# Grobbel Environmental & Planning Associates L.L.C.

REVISED May 19, 2009

**RE: Preliminary Review and Public Comment, Proposed Cherry Berry B1-25 SWD, Class II Injection Well Draft Permit #MI-055-2D-0042, NW ¼, SW ¼, NW ¼, Section 25, T28 R10W, Acme Township, Grand Traverse County, Michigan.**

Source: 2005 Orthophotograph, Grand Traverse County website, <http://gis.co.grand-traverse.mi.us/gis>.

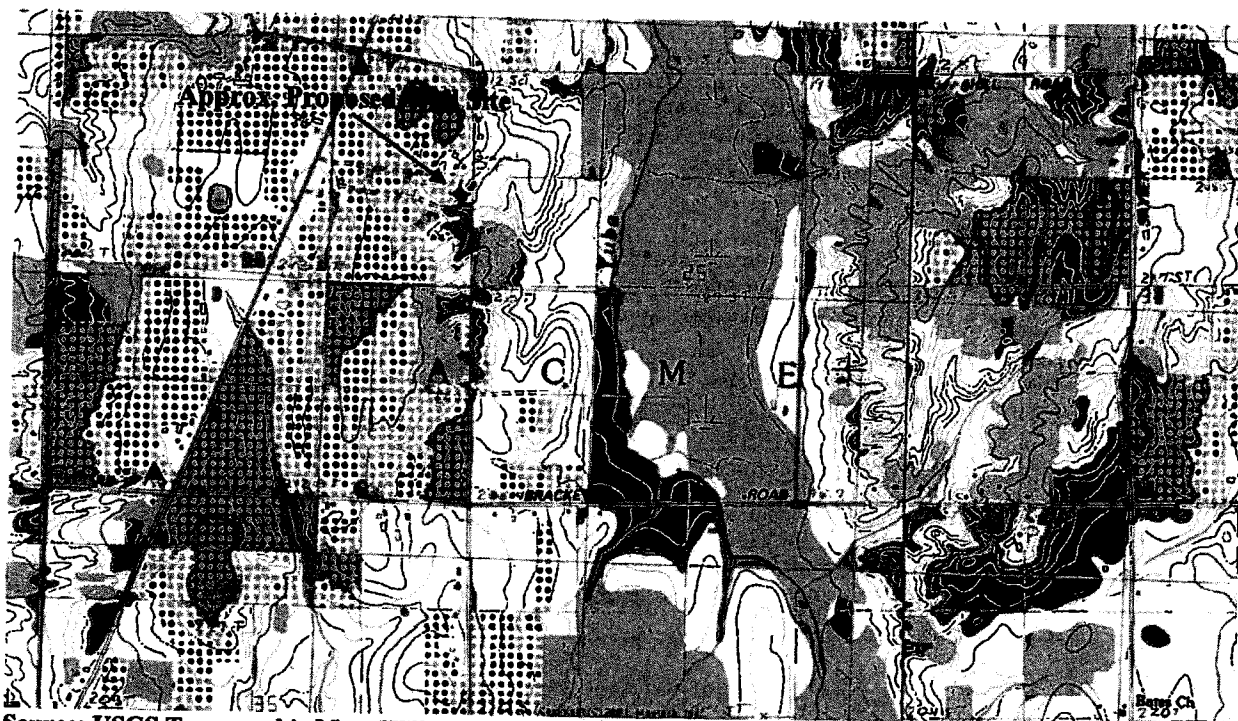
The proposed Cherry Berry deep injection well would be located along or near the eastern boundary of parcel No. 01-226-002-02, owned by Cherries R Da Berries, LLC, of Kewadin, Michigan, and near the eastern boundary of parcel No. 01-225-009-00, also owned by Cherries R Da Berries, LLC.

**MDEQ Well Head Protection Area  
Lochenheath, Acme Township  
Grand Traverse County, Michigan**

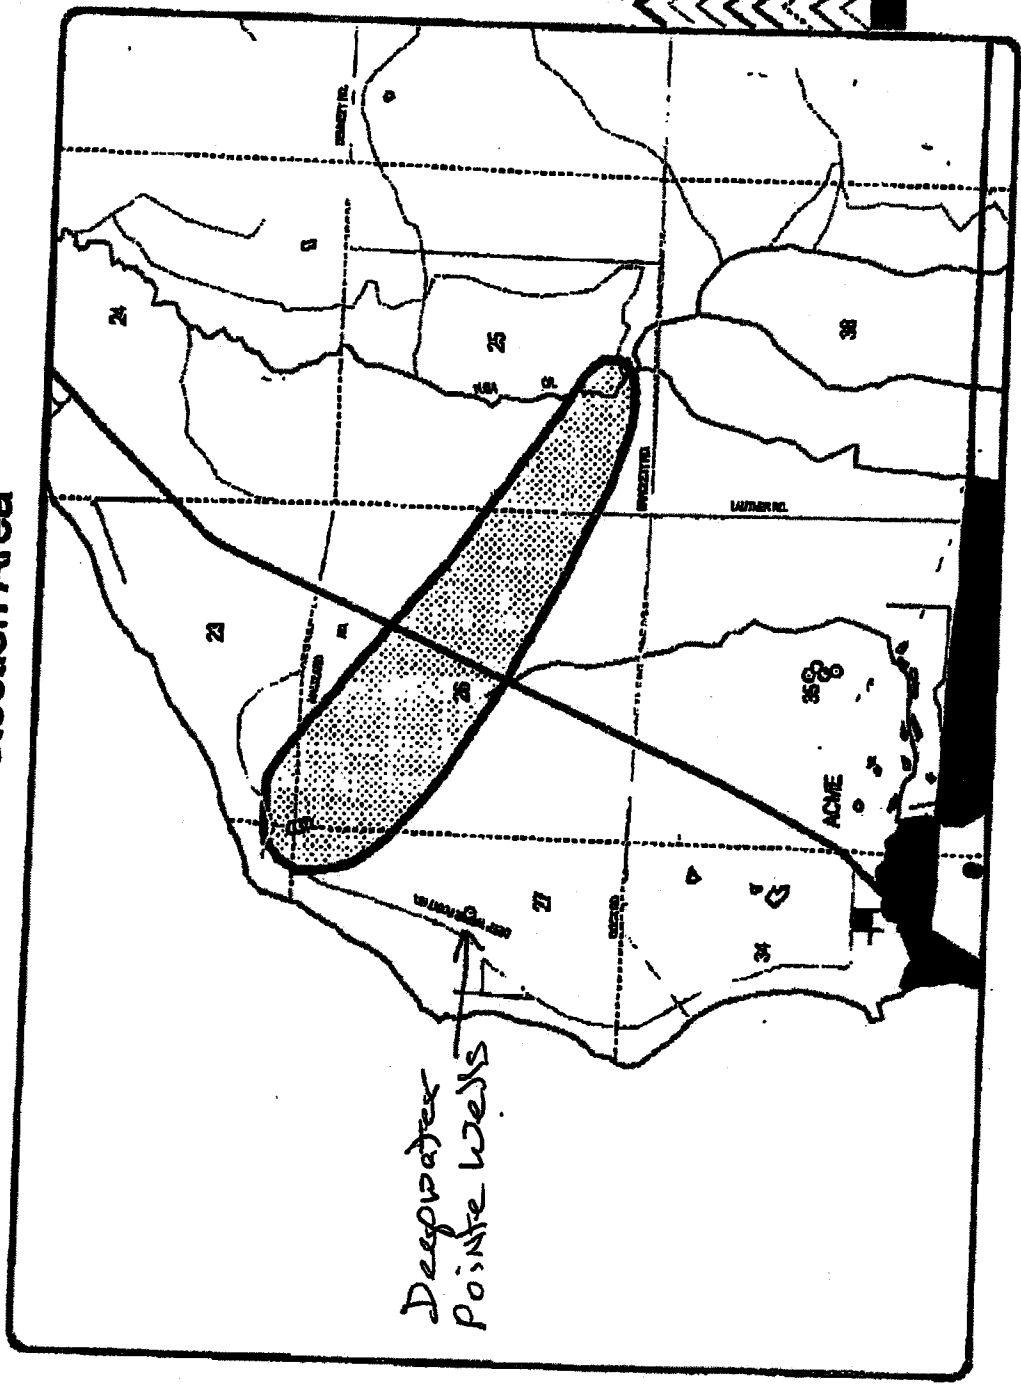
The proposed Cherry Berry deep injection well site exists approximately one-thousand (1,000') feet north-northwest of a potable water well at an adjacent residence located at 7490 Lautner Road, parcel No. 01-225-011-00. Finally, the proposed Cherry Berry well site exists near, slightly north of and up groundwater flow direction from within the wellhead protection area (WHPA) as defined for the Lochenheath residential and golf course development.<sup>5</sup> Refer to Appendix B for a copy of the MDEQ Lochenheath Well Head Protection Area map.
